File: A171/21

Address: 20 Cipriano Ct Woodbridge

Minor Variance Application

Purpose: Relief from By-law 1-88, as amended, is being requested to permit the construction of a proposed cabana located in the rear yard.

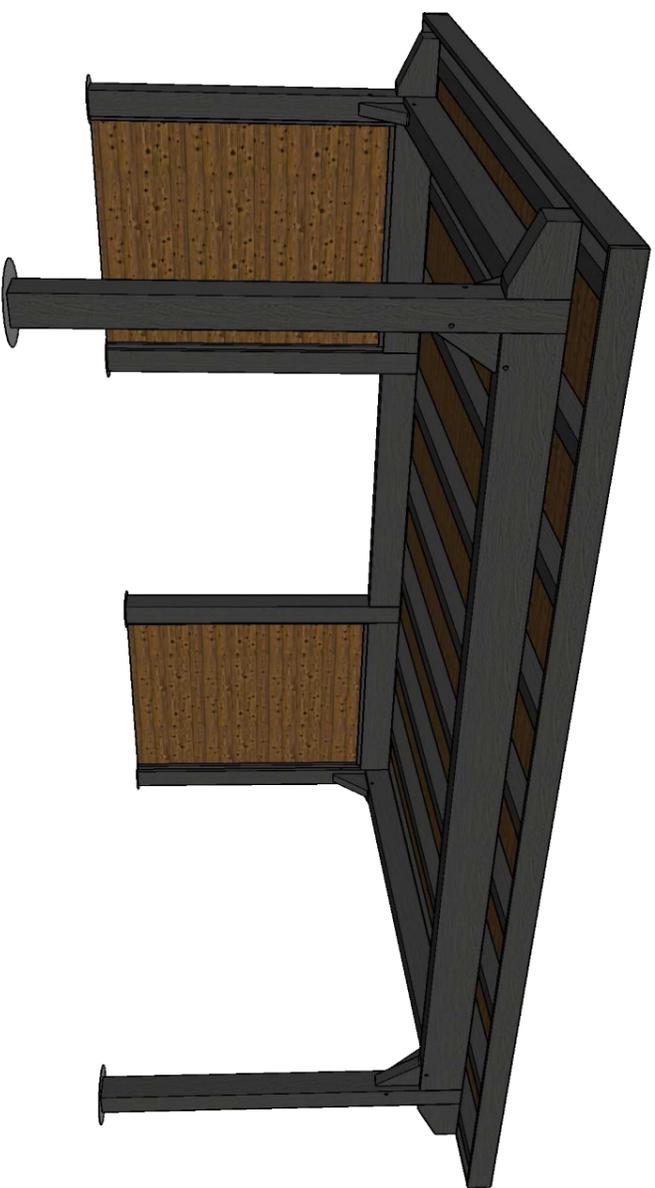
The Owner is proposing to construct a cabana in the rear yard with a requested rear and interior side yard setback of 1.22 m, and a proposed reduction to the required rear yard soft landscaping.

The Development Planning Department has no concerns with Variances 1 and 2. The proposed cabana is covered and unenclosed and maintains the as-of-right height and area permissions, which helps mitigate impacts resulting from the reduced rear and interior side yard setbacks. The subject property also abuts an open space area at the rear, which is screened by existing cedar hedges within the subject property.

The Development Planning Department has no objection to Variance 3, as the requested reduction in the required soft landscaping in the rear yard is considered minor and will not have an impact on neighbouring properties. The Development Engineering Department has reviewed the application and has no concern with the reduction in soft landscaping.

The owner is now proposing works that result in the increase in the hard landscaping area of lot coverage from 60% to 58.6% which result in the difference of 1.4%. The additional hard surface lot coverage will have an impact on storm water runoff. In order to minimize the water runoff, staff recommend the owner introduce Low-impact Development (LID) measures where suitable e.g., flower gardens, Bioswales, Permeable pavement, Infiltration trenches.
